**PROJECT:** Souther Tier Logistics  
Village of Horseheads  
Municipal Inspection  
June 29, 2022

**BY:** Jessica Verrigni, CPESC, CPSWQ

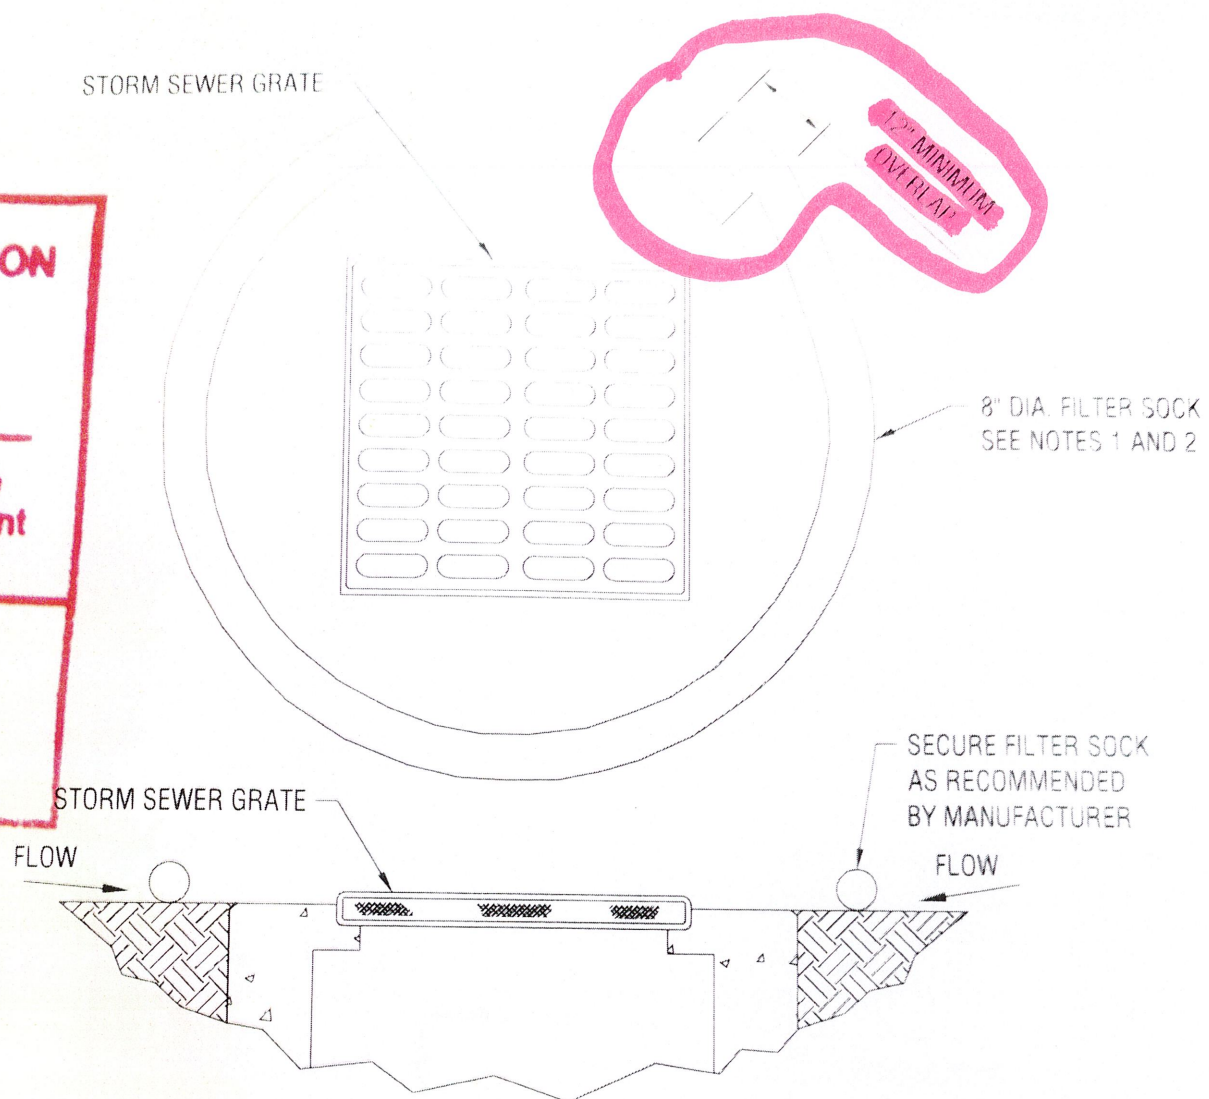
Concrete washout not being used.

Silt fence installed incorrectly.

Concrete washout doesn't have liner. The other one has a liner but it isn't held in place correctly.

Silt sock is supposed to be along the entire east side of building. None is in place.
